RECEIPT DATE: 5/11/2023 **ONSITE SEWAGE DISPOSAL SYSTEM**

PROPERTY ADDRESS: 4890 Castlebridge Road

RE: 4890 Castlebridge
Carroll-Ziegler Property, Lot 5

SEPTIC PLAN
CARROLL-ZIEGLER PROPERTY, LOT 5
4890 CASTLEBRIDGE ROAD
ZONED: RC-DEO
TAX MAP NOS: 23 & 29 GRID NOS: 21, 22 & 3, 4 PARCEL NO: 29
THIRD ELECTION DISTRICT HOWARD COUNTY, MARYLAND
SCALE: AS SHOWN DATE: JUNE, 2018
SHEET 1 OF 1

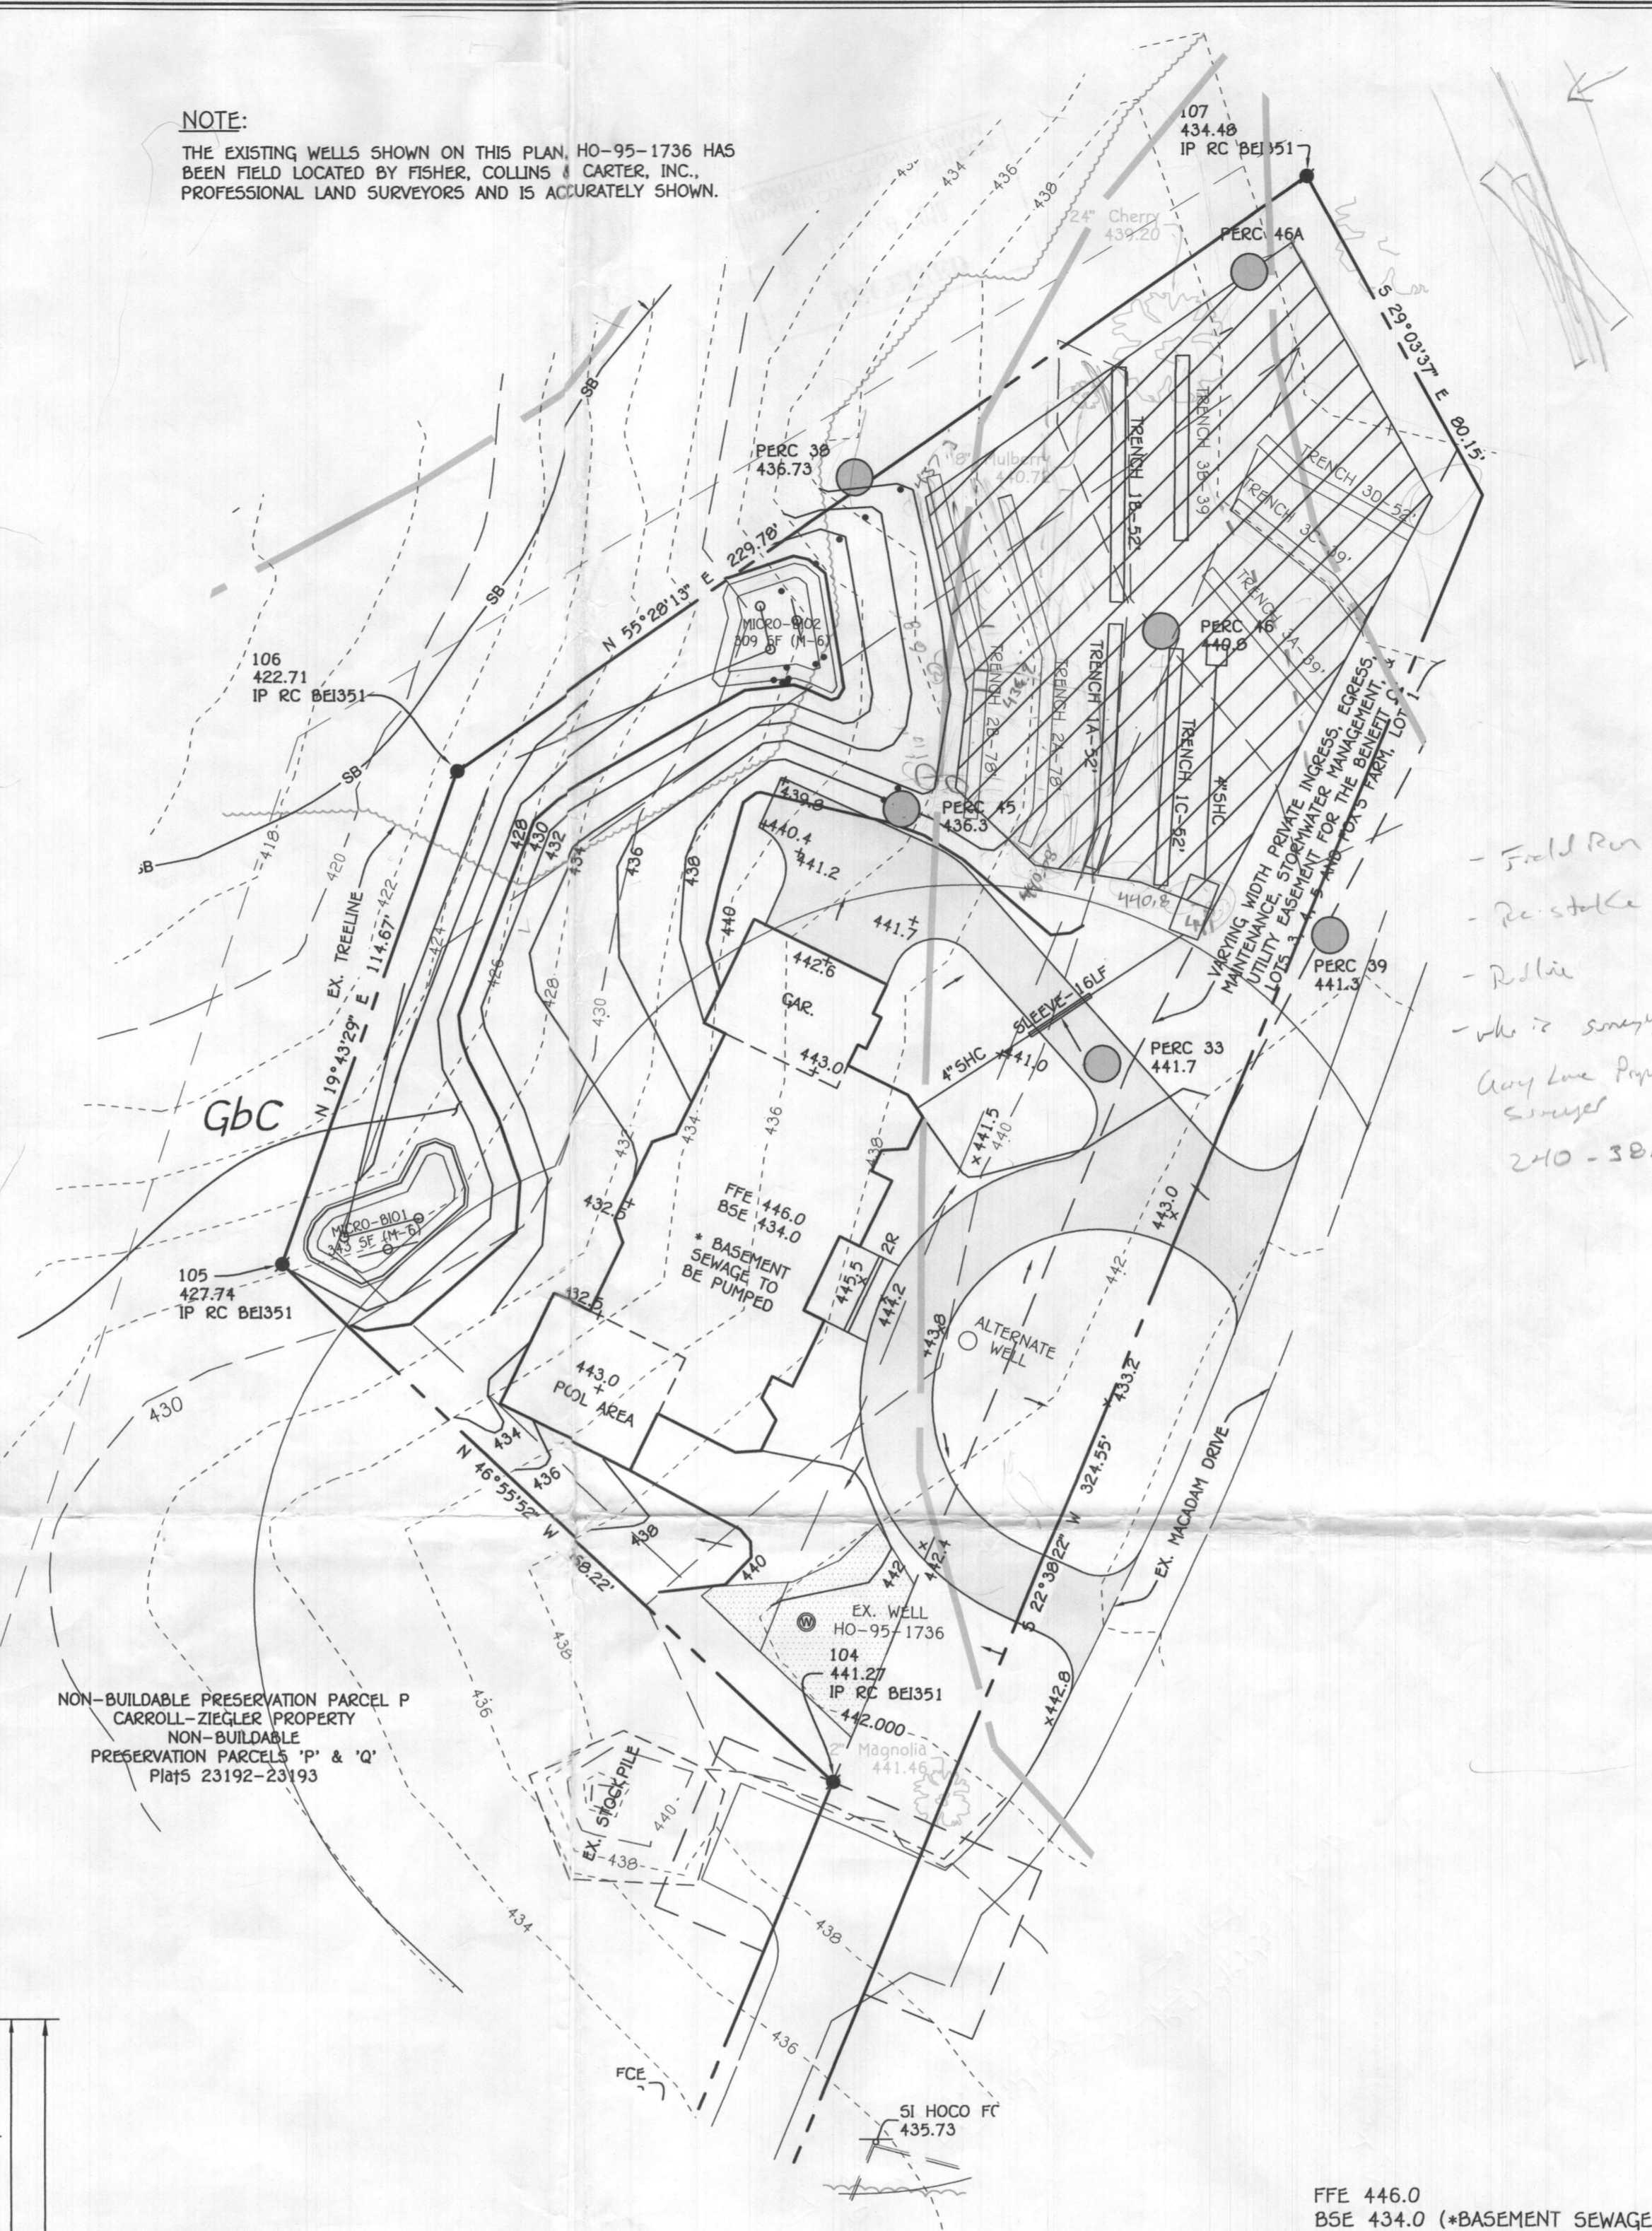
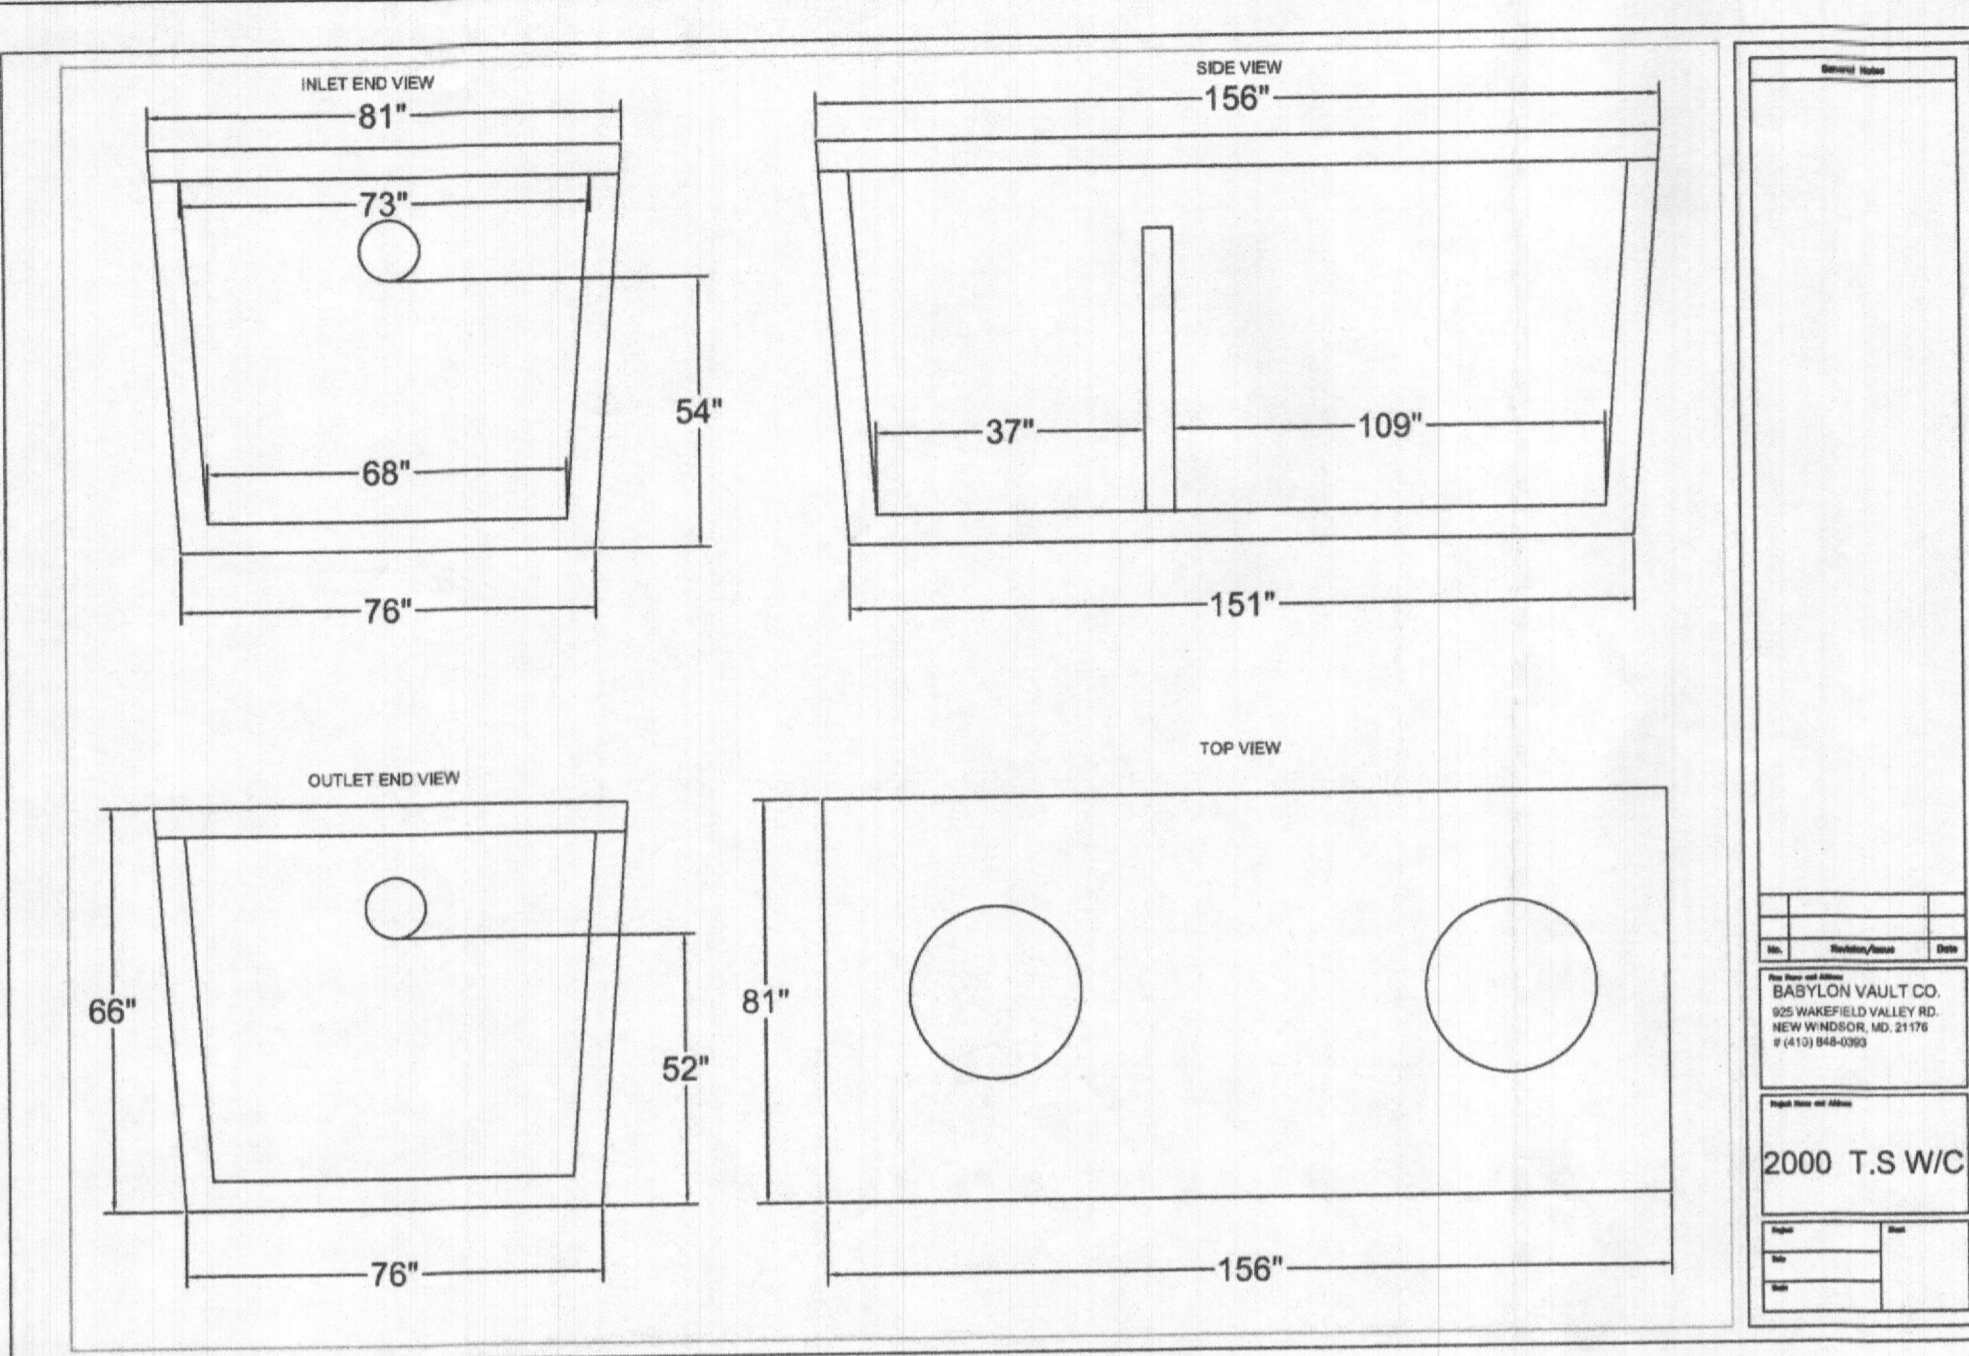
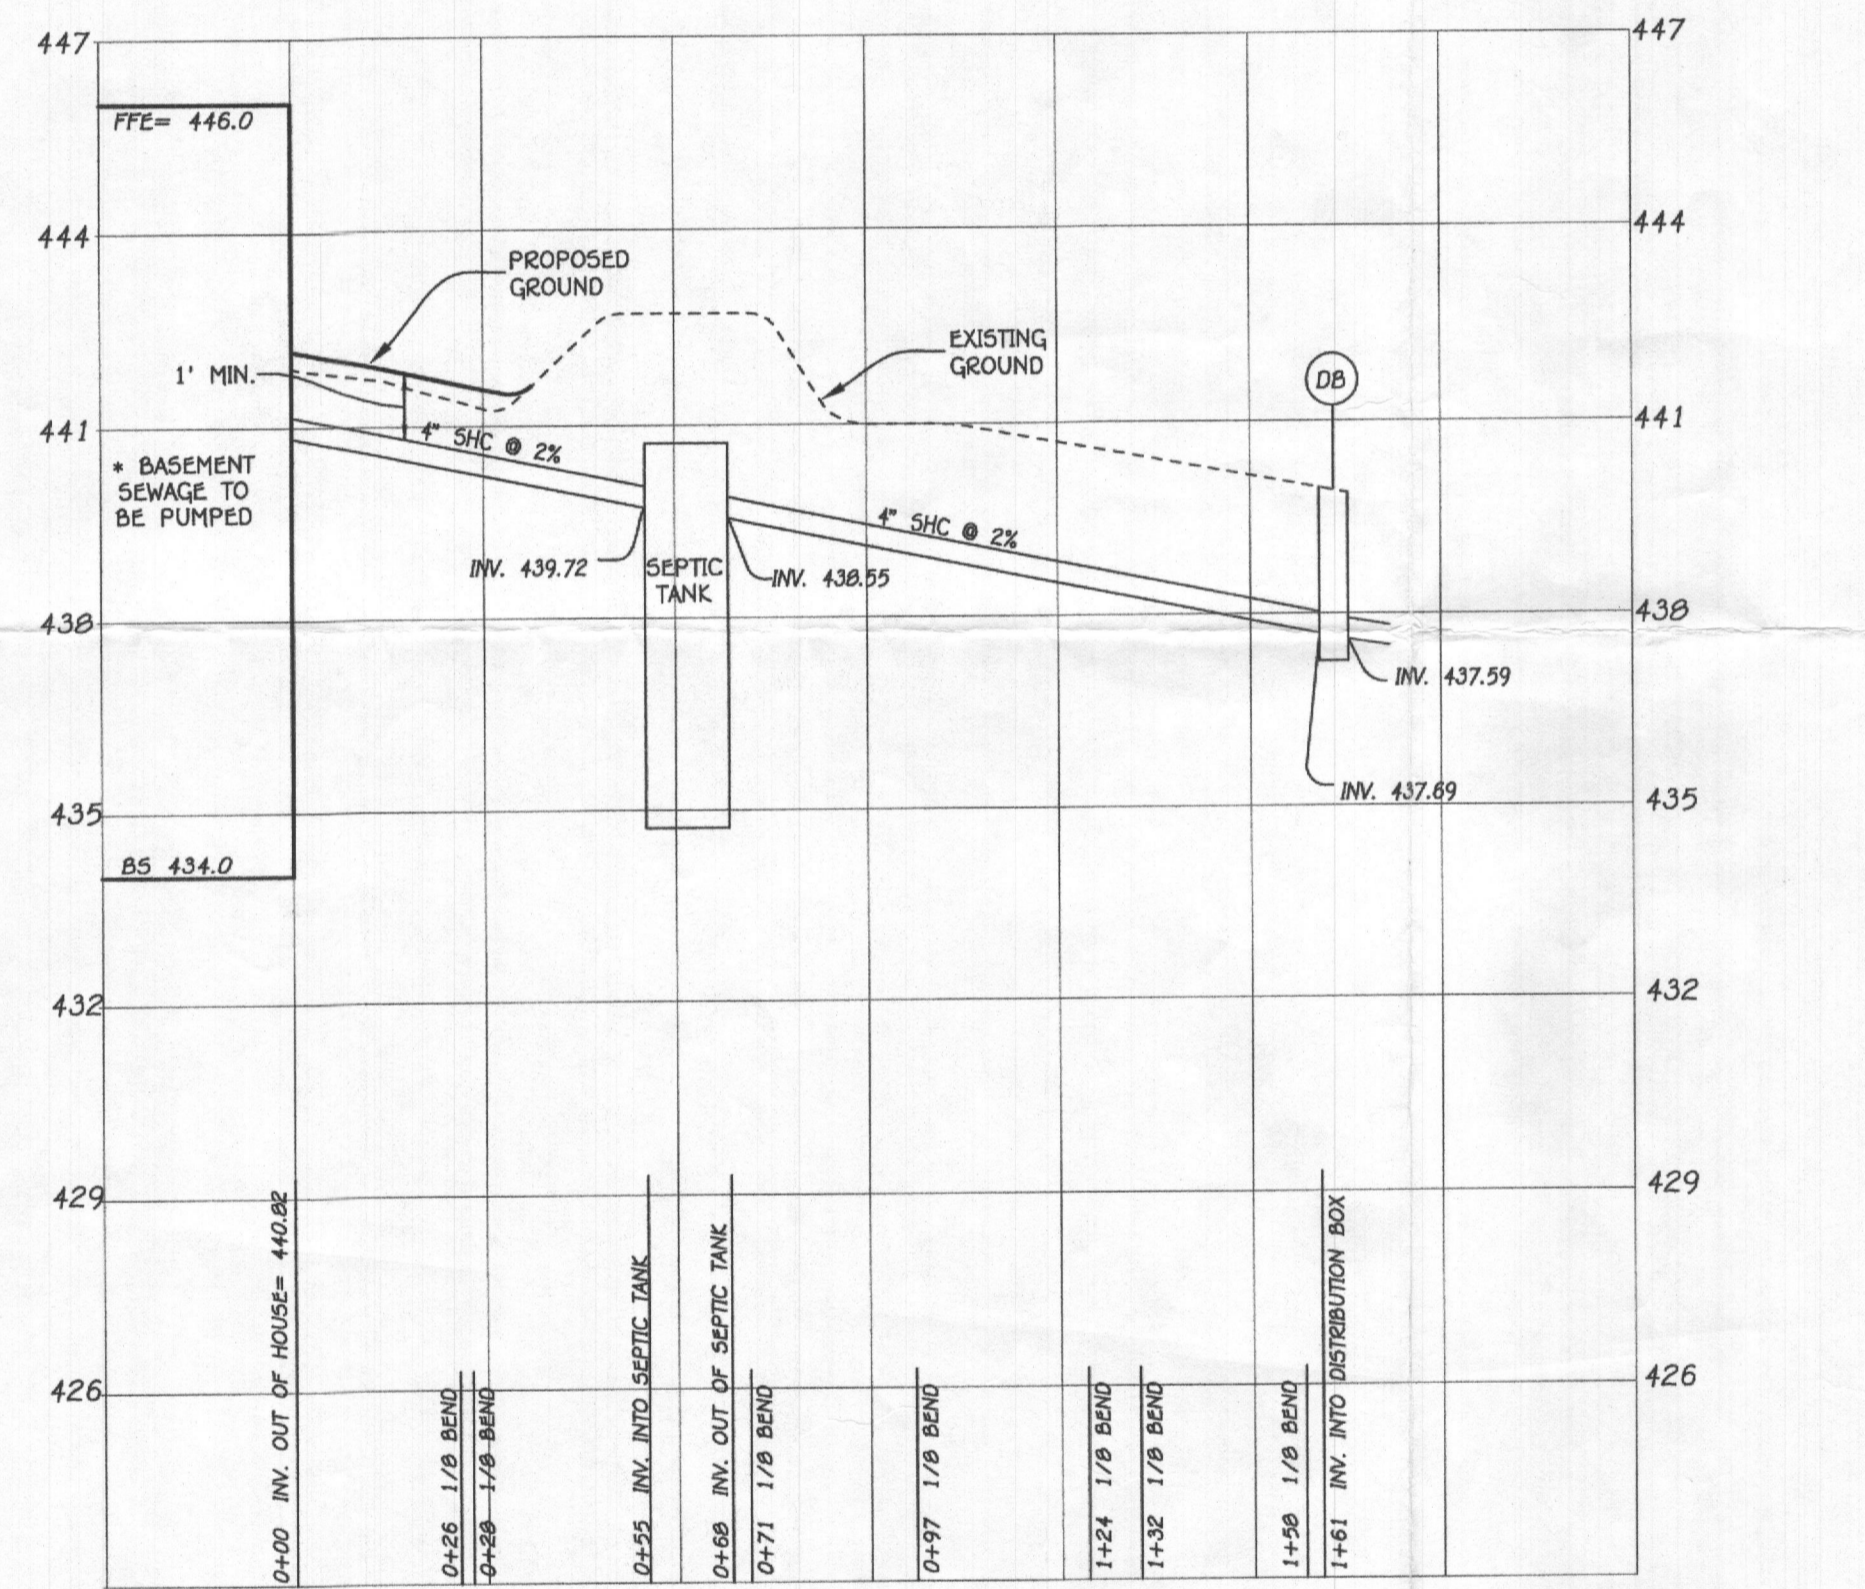
The OSDS Plan for has been reviewed with the following comments:

- 1.) Utilize area near perc test holes 38 & 45.
- 2.) Avoid area near perc test hole 46A.
- 3.) Move tank to the corner of the SDA.
- 4.) Show sleeve on pipe underneath driveway.
- 5.) Add address to plan.
